MONTGOMERY COUNTY HISTORIC PRESERVATION COMMISSION
STAFF REPORT

Address:	7420 Cedar Avenue, Takoma Park	Meeting Date:	9/4/2024
Resource:	Contributing Resource Takoma Park Historic District	Report Date:	8/28/2024
Applicant:	Tim Pittman (Cristina Chaves Vargas, Agent)	Public Notice:	8/21/2024
Review:	HAWP	Tax Credit:	n/a
Permit No.:	1082079	Staff:	Dan Bruechert
Proposal:	Skylight With Integrated Solar Panel Installation

VELUX Sky-Product Management	VELUX 1418 Evans Pond Road Greenwood, SC 29649 1-800-88-VELUX www.VELUXUSA.com	Name	Date
	VSS-Residential/Commercial Roof Section (Light Shaft and Asphalt Shingles)	JDH	July 2020
		Checked by	WQ, JL July 2020
		Drawing No.	VSS-02-0720

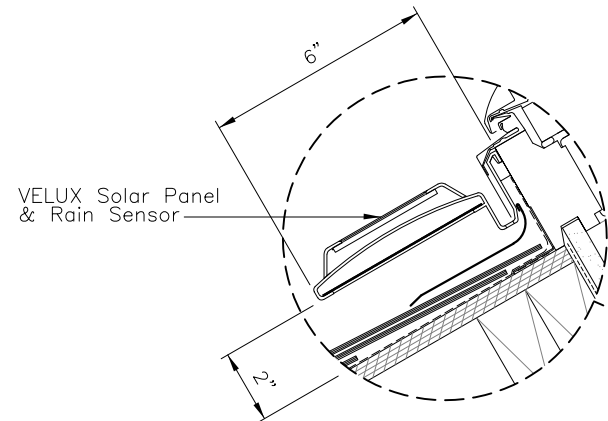
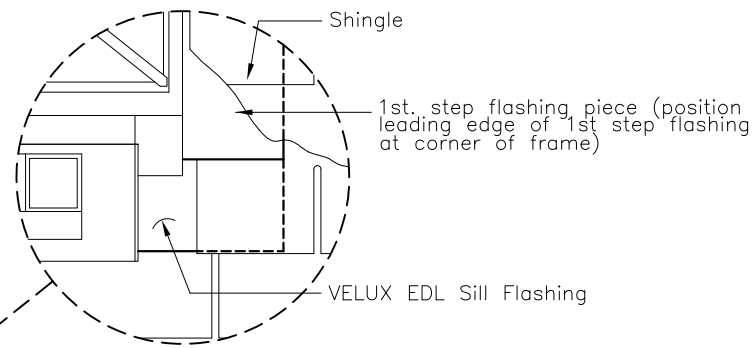
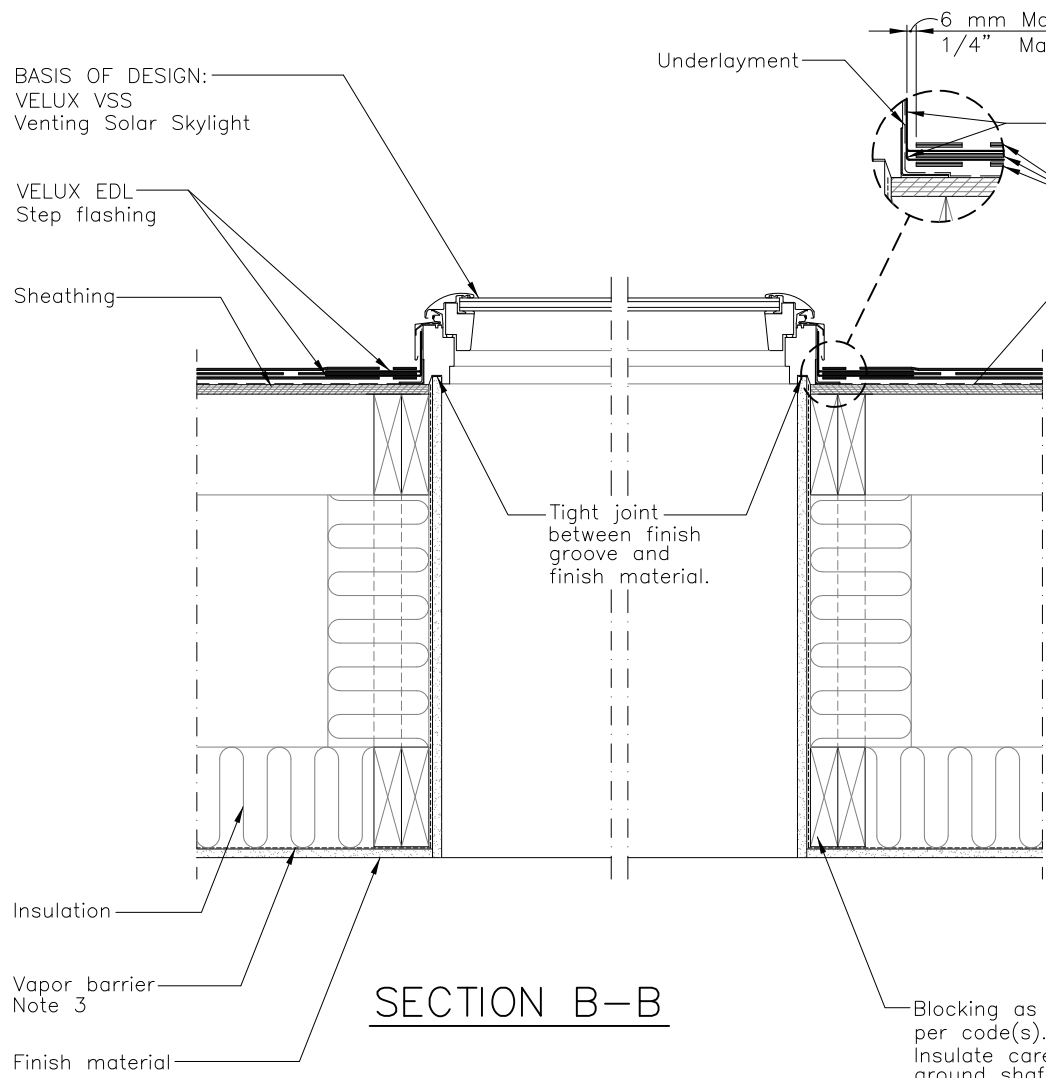
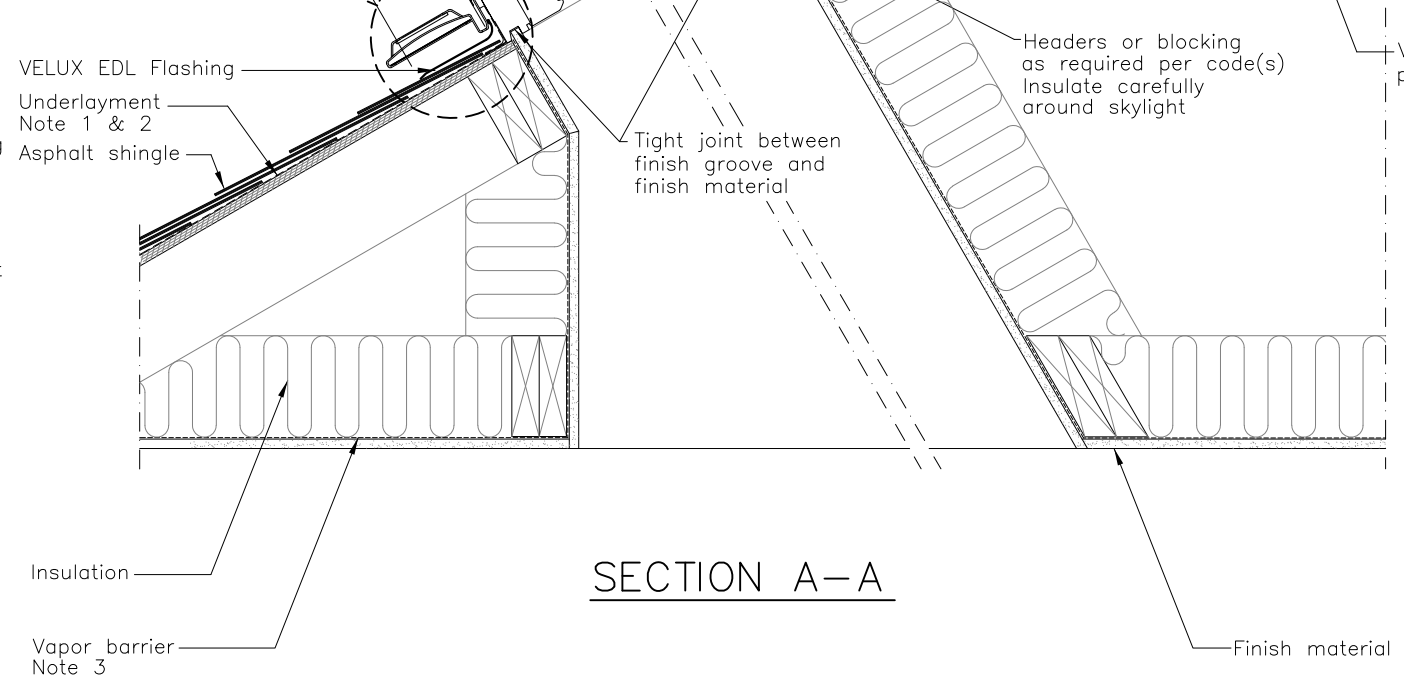
Figure 2: Product image of the proposed skylight.

The HPC typically encourages applicants to avoid installing skylights on the front-facing roof slopes to preserve the architectural character of the house and surrounding district. In this instance, however, there are already three skylights on the front roof slope. Staff finds it is appropriate to remove the existing skylights and install new skylights in the existing roof openings as the integrity of the roof has already been altered. Staff further finds the proposed skylights are appropriate materials and designs. The dark aluminum frames will not contrast with the dark shingle roof and, based on Staff's observation at other properties, the frames are not highly reflective. These skylights have the added feature in the form of the solar panels. Staff finds the solar panel is a relatively unobtrusive feature, that is approximately 6" (six inches tall) and nearly the full width of the skylight. Staff finds the appearance of the new skylights on the front-facing gable will be an improvement over the existing bubble skylights.

Staff recommends that the Commission **approve** the HAWP application under the Criteria for Issuance in Chapter 24A-8(b)(2), and (d), having found that the proposal will not substantially alter the exterior features of the historic resource and is compatible in character with the district and the purposes of Chapter 24A;
